PROJECT: Residential Development at Sunnyside, Yapton Road, Barnham

REPORT: 2413/TN/04/A – Technical Note to WSCC Highway Consultation Response

LPA REFERENCE: BN/73/26/OUT

Figure 2 – Swept path example, current situation (ignoring bollard)

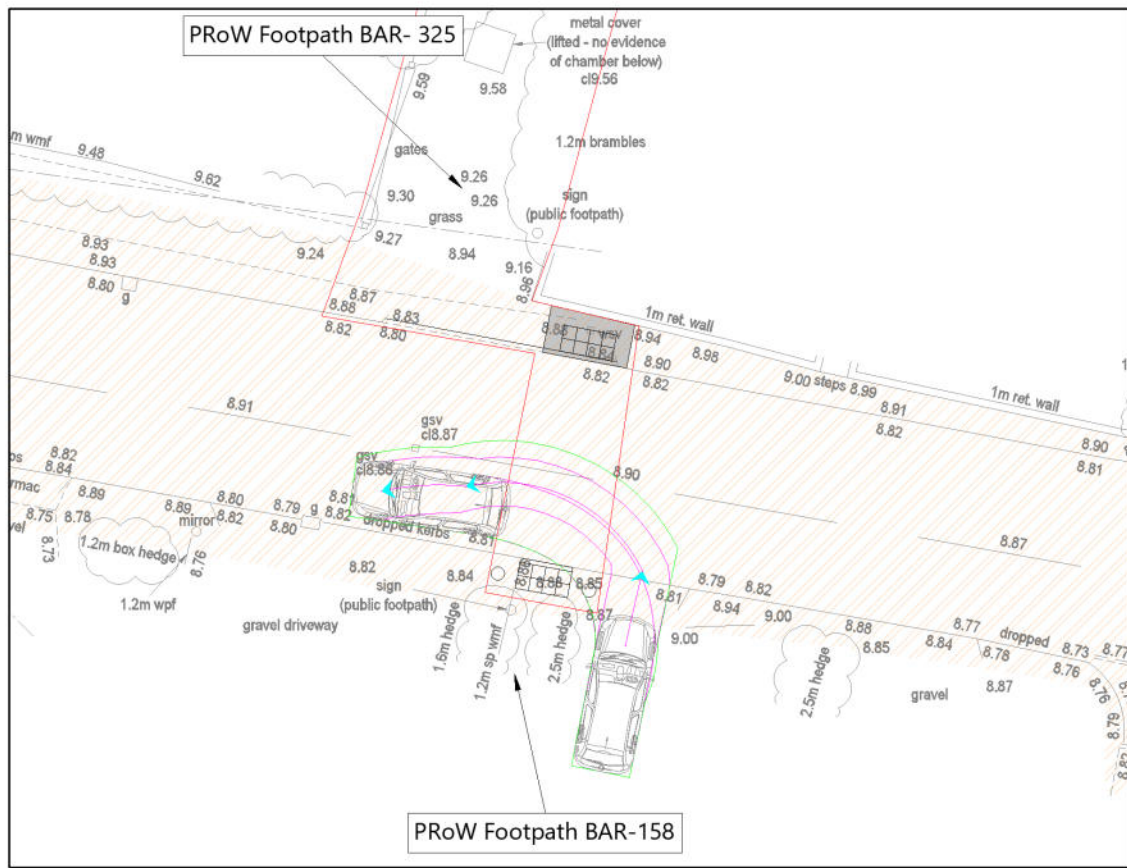
11. It is not considered that the addition of bollards will be an issue because:
 - i. The outbound manoeuvre for westbound vehicles already encroaches into the oncoming lane now (see example in **Figure 2**), and therefore 'with bollards' there is no material change

- ii. The bollards as shown on the drawing are around twice the size they would be, which allows for a buffer
12. In any event, this matter can be resolved at detailed design.

13. In summary, it is not considered that this point should prevent a highway recommendation from being made.
